ITEM: 6.5	REPORT SUMMARY MINOR VARIANCE APPLICATION FILE NUMBER A210/24
------------------	------------------------------------------------------------------------------

MINOR VARIANCE APPLICATION FILE NUMBER A210/24

CITY WARD #:	2
APPLICANT:	Giuseppe & Jaclyn Lina Luca
AGENT:	Victor Araujo (Citi-Core Group Construction Management Ltd.)
PROPERTY:	129 Lio Avenue, Woodbridge
ZONING DESIGNATION:	See below.
VAUGHAN OFFICIAL PLAN (2010) DESIGNATION:	Vaughan Official Plan 2010 ('VOP 2010'): "Low Rise Residential"
RELATED DEVELOPMENT APPLICATIONS:	N/A
PURPOSE OF APPLICATION:	Relief from the Zoning By-law is being requested to permit the construction of a swimming pool and cabana in the rear yard, driveway extension and reduced front yard landscaping requirements.

EXISTING INGROUND POOL AND PROPOSED CABANA SITE PLAN
129 LEO AVENUE
WOODBRIIDGE, ONTARIO L4H 2R9

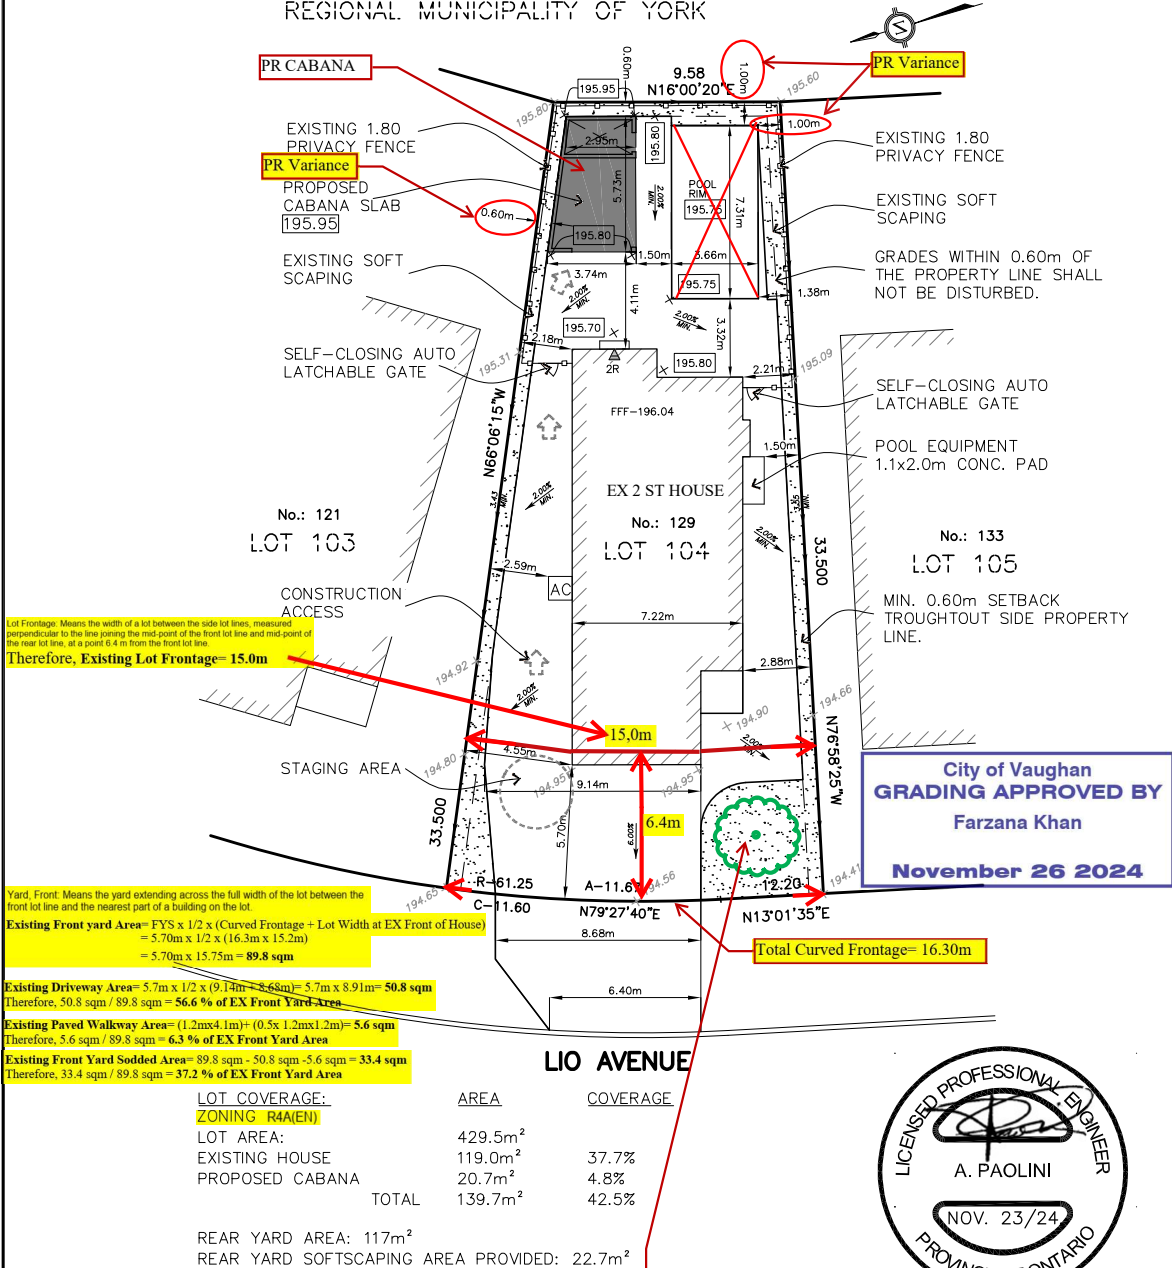
**See Schedule B for Development Planning Comments.	
Development Planning Recommended Conditions of Approval:	That prior to the issuance of a Building Permit, the Owner shall submit photographic evidence, to the satisfaction of Development and Parks Planning staff, of an Eastern Red Cedar tree 200 cm in minimum height or a Silver Mapletree 50 mm in minimum caliper planted at 129 Lio Avenue in accordance with the site plan drawing approved through minor variance file A210/24.

The Development and Parks Planning Department has no objections to Variance 1 to increase the maximum driveway width from 9 m to 9.14 m and Variance 5 to decrease the minimum landscape coverage from 50% to 43.4%. The 0.14 m increase in maximum driveway width is not anticipated to have any negative impacts and is minimal in nature. Development Engineering staff have reviewed Variance 5 and have indicated that soft landscaping deficiency is not anticipated to incur any negative stormwater management impacts in the front yard.

The Development and Parks Planning Department has no objections to Variances 2 and 3 to reduce the setbacks from the rear and south interior lot lines to the outdoor swimming pool from 1.5 m to 1.0 m. The proposed 1.0 m setbacks maintain sufficient separation for access and maintenance. A 1.8 m privacy fence is located along the rear and south lot lines and is anticipated to mitigate any noise and privacy impacts.

The Development and Parks Planning Department has no objections to Variance 4 to reduce the setback from the cabana to the north interior lot line from 1.2 m to 0.6 m. The proposed cabana has a modest mass that complies with maximum height and lot coverage provisions. The reduced setback maintains sufficient space for access, and is not anticipated to incur negative massing impacts on the neighbouring properties.

REVISION FEB. 6, 2025, AS REQUIRED BY VAUGHAN DEVELOPMENT AND PARKS PLANNING DEPARTMENT.
Proposed new private tree to be planted in front yard area. Proposed "eastern Red Cedar" or a "Silver Maple". Options for the new tree shall be a coniferous tree of 200 cm in height or a deciduous tree of 50 mm in caliper as identified in the Vaughan Citywide Streetscape Guideline, Appendix D - Tree and Plant Species List.

1. That prior to the issuance of a Building Permit, the Owner shall submit photographic evidence, to the satisfaction of Development and Parks Planning staff, of an Eastern Red Cedar tree 200 cm in minimum height or a Silver Maple tree 50 mm in minimum caliper planted at 129 Lio Avenue in accordance with the site plan drawing approved through minor variance file A210/24.
